1984 - 1987 Corvette: Service Bulletin: Loose Corvette Door Trim Panel

Source: Chevrolet Dealer Service Bulletin

Bulletin Number: 87-116, Number 10

Date: April, 1987

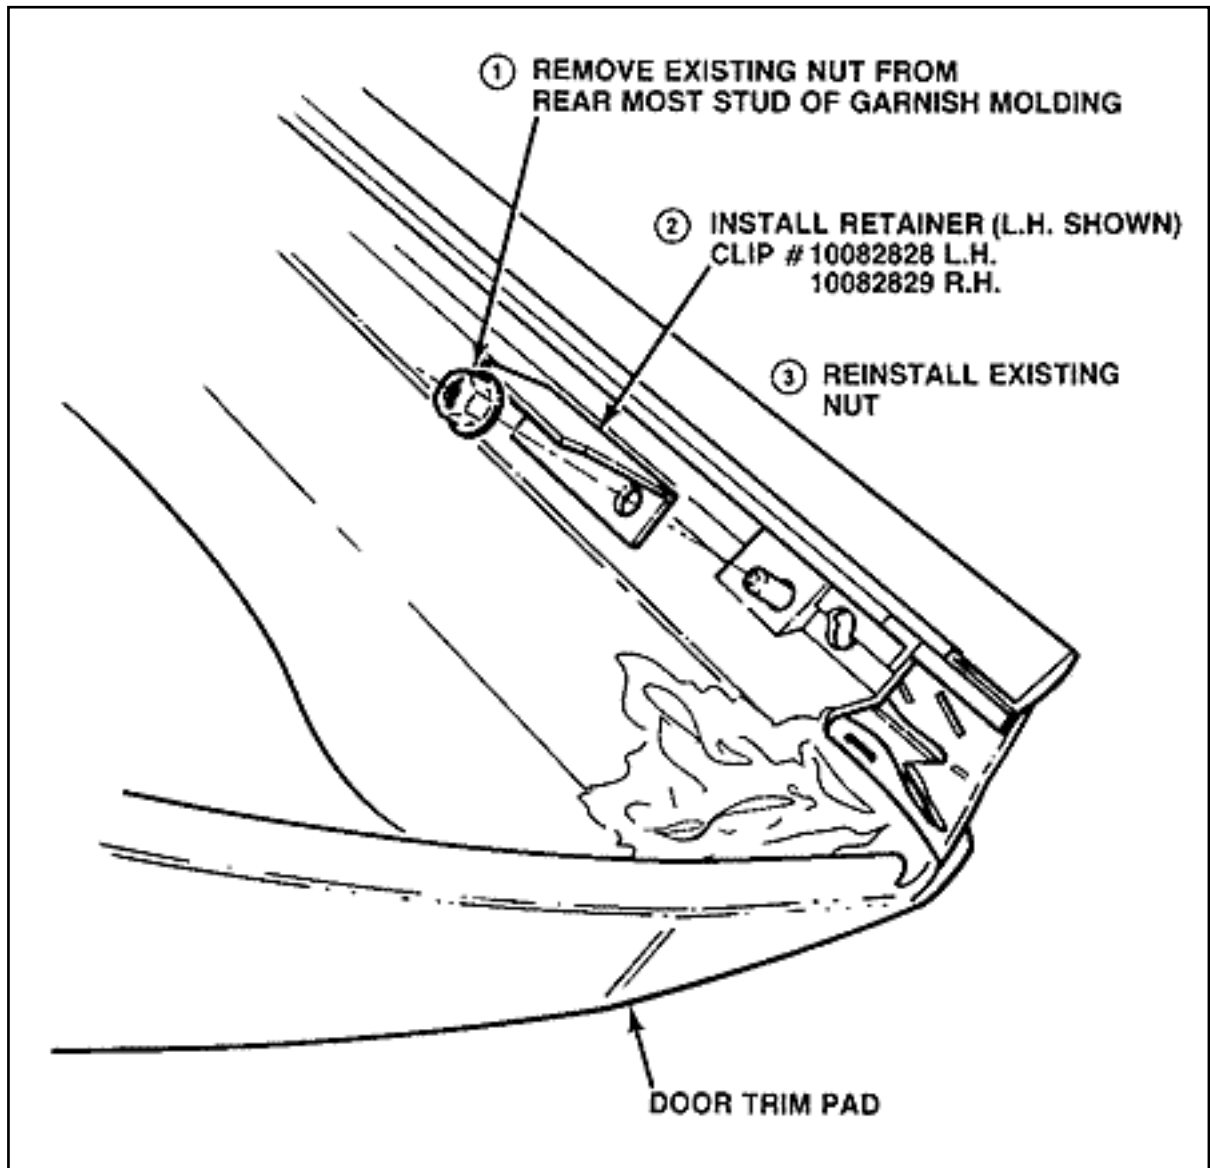
Some 1984-87 Corvette door trim pads may be loose from the door inner panel at the rear upper edge of the door.

If this condition is found it may be repaired by adding a retainer to the door trim panel using the following procedure.

1. Remove door trim panel per instructions in the Corvette Shop Manual.
2. Install retainer, P/N 10082828-9, L.H./R.H. as illustrated, to the trim pads rear upper garnish molding stud using spin nut. (See Illustration)
3. To remove a trim panel with a retainer, push trim panel upward and outboard to disengage clip from door inner panel at beltline.
